* July 08 - length reduced / front stepped back / porch added *

* Aug 08 - sketch detail extension moved to rear for TFC enquiry - note

* Sept 08 - extension re sized & stepped forward to allow greater open area

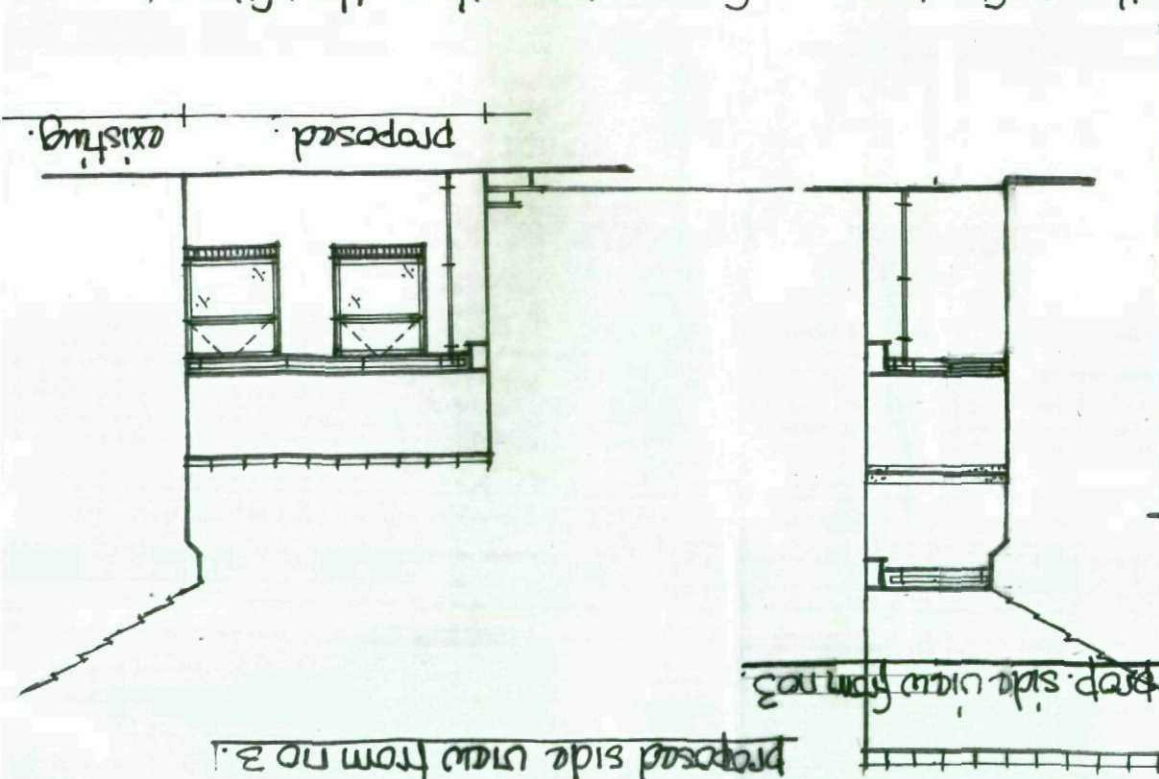
* off look from both kitchen + lounge window of no 9 made worse than orig *
